Access Compliance Report

Public Rights-of-Way

(Curb Ramps)

Intersection ID: 50729	Main Street: TODDINGTON_LN	Cross Street: ALDERGROVE_RD	Location: S
ADA ID: F014A8E43749	Ramp Type: PerpDiag	Initial Pass/Fail: Fail	Overall Compliance: No
		Severity Score: 10

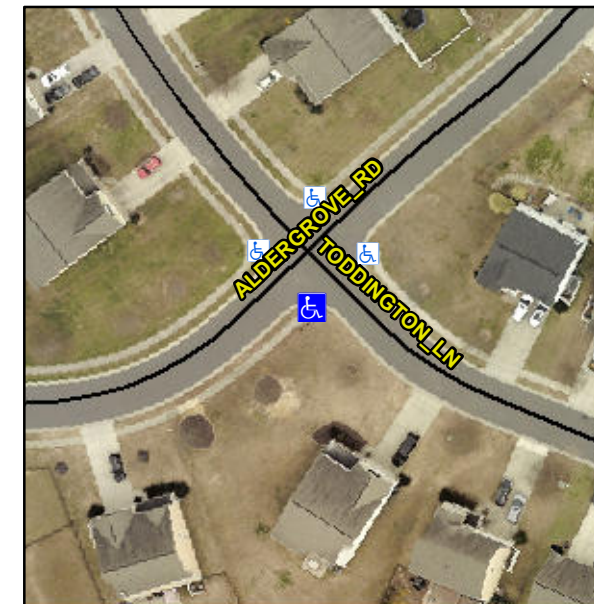
Compliance	Description	Data	Compliance	Description	Data
N/A	Ramp Length (in)	49.0	Yes	Ramp Slope (%)	6.2
No	Ramp Width (in)	47.0	No	Ramp XSlope (%)	3.4
N/A	Flare Type LT	N/A	N/A	Flare Type RT	N/A
N/A	Flare Slope LT (%)	N/A	N/A	Flare Slope RT (%)	N/A
N/A	Flare Traversable LT?	N/A	N/A	Flare Traversable RT?	N/A
N/A	Landing Length (in)	N/A	N/A	DWS Provided?	N/A
N/A	Landing Width (in)	N/A	N/A	DWS Contrast?	N/A
N/A	Landing Slope (%)	N/A	N/A	DWS Length (in)	N/A
N/A	Landing X Slope (%)	N/A	N/A	DWS Full Width?	N/A
N/A	Landing Curb? (Y/N)	N/A	N/A	DWS Offset (in)	N/A
N/A	Shared Landing?	N/A			
N/A	Gutter Ponding?	N/A	N/A	Gutter Slope (%)	N/A
N/A	Gutter Lip Ht (in)	N/A	N/A	Gutter X Slope (%)	N/A
N/A	Painted X Walk1?	No	N/A	Painted X Walk2?	No
	X Walk 1 Direction	To NE		X Walk 2 Direction	To NW
N/A	X Walk 1 Width (in)	N/A	N/A	X Walk 2 Width (in)	N/A
	X Walk 1 Slope (%)	3.2		X Walk 2 Slope (%)	2.5
	X Walk 1 X Slope (%)	2.1		X Walk 2 X Slope (%)	4.2

Remove & Replace Curb Ramp With Two New Directional Ramps or Equivalent.
